CITY OF ALBUQUERQUE

Re: Paleta Bar/Spring Roll Restaurant
317 Gold Ave. SW
Traffic Circulation Layout
Architect's Stamp 04-06-2020 (H14-D223)

SITE PLAN / TRAFFIC CIRCULATION LAYOUT

RESTAURANT REMODEL

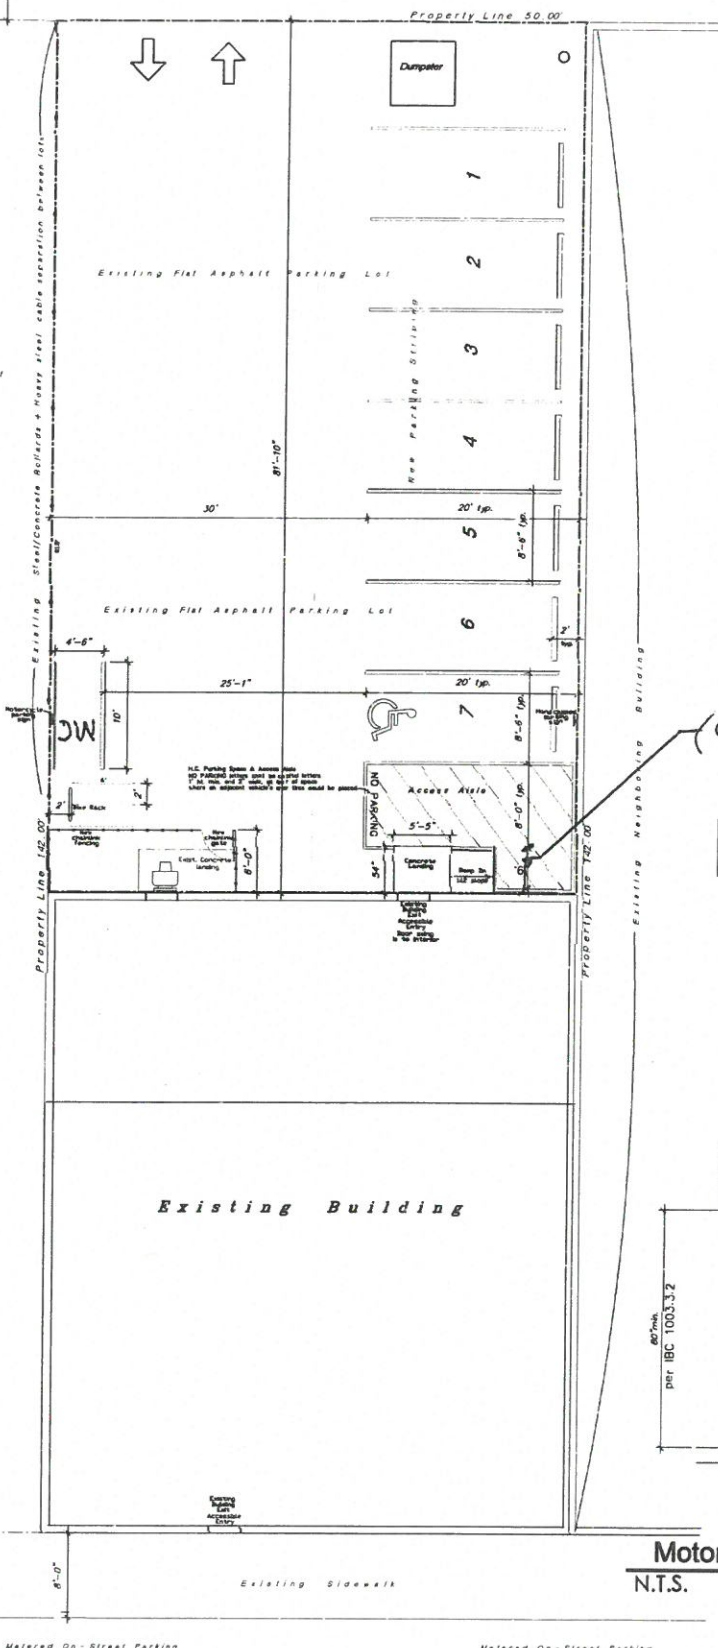
ALL WHEELCHAIR RAMPS LOCATED
WITHIN THE PUBLIC RIGHT OF WAY
MUST HAVE TRUNCATED DOMES.

All broken or cracked sidewalk must be replaced with sidewalk
and curb & gutter per City standard drawing 2415A Standard
C & G and 2430(sidewalk)
